Project: LODI UNIFIED SCHOOL DISTRICT
BEAR CREEK HIGH SCHOOL RESTROOMS MODERNIZATION

ADDENDUM 1

10/26/2023

A50.1

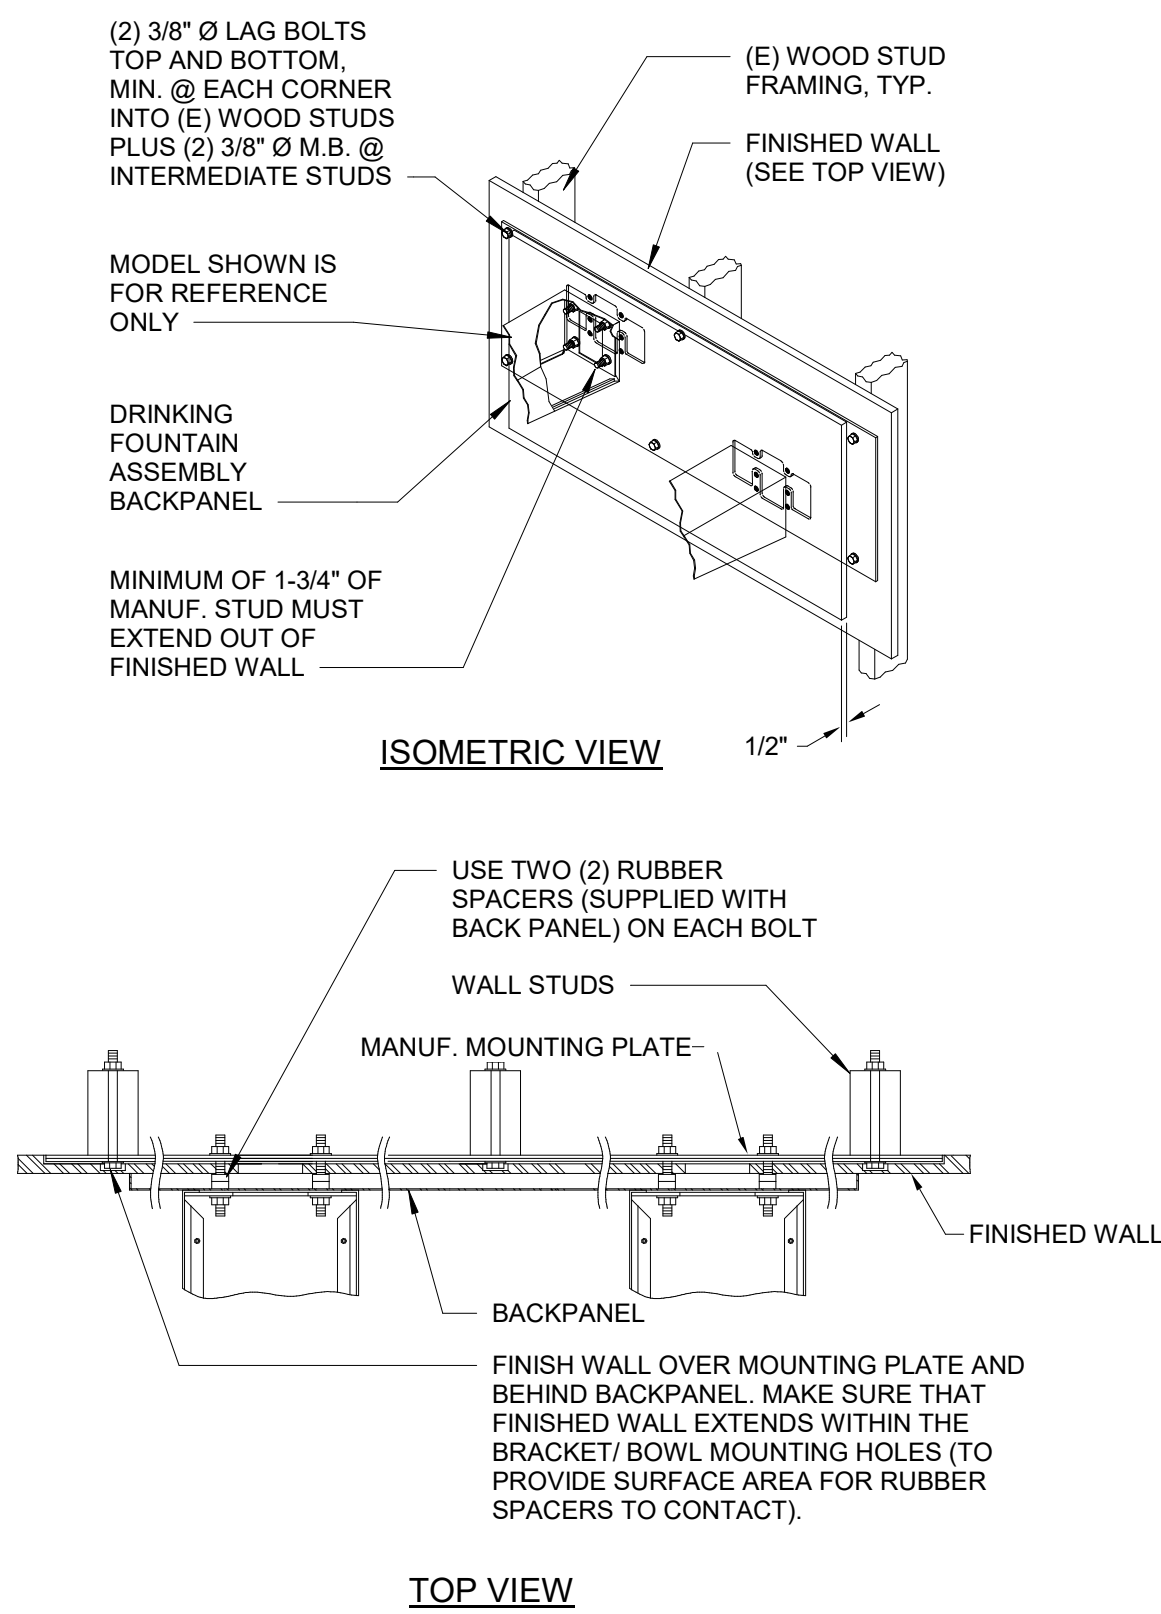
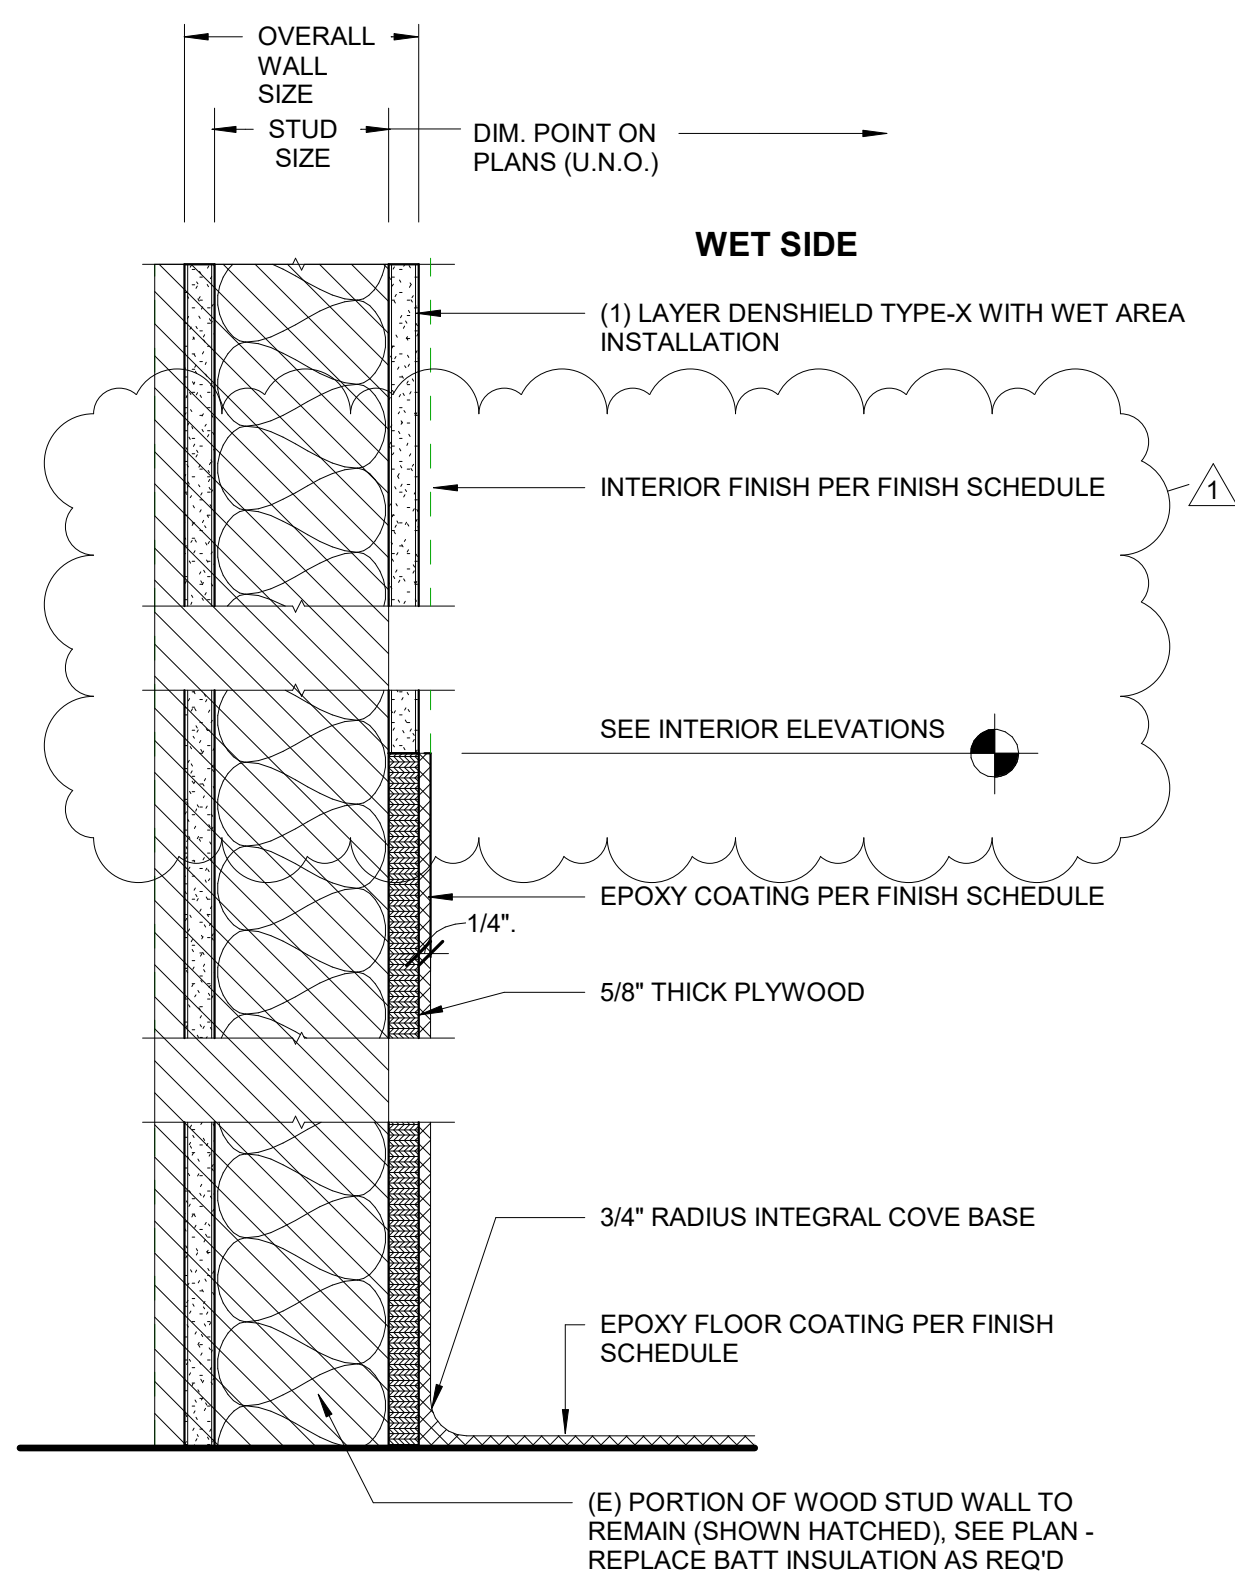
- E. A50.1: Finish & Door Schedules and Details
 - a. Revised Interior Finish Legend to replace FRP at walls with painted gypsum board
 - b. Revised Finish Schedule to replace FRP at walls with painted gypsum board

- c. Revised Restroom Wall Detail (detail 1) to remove FRP, and instead show the epoxy wainscot on plywood to +7'-2", with painted gypsum board above
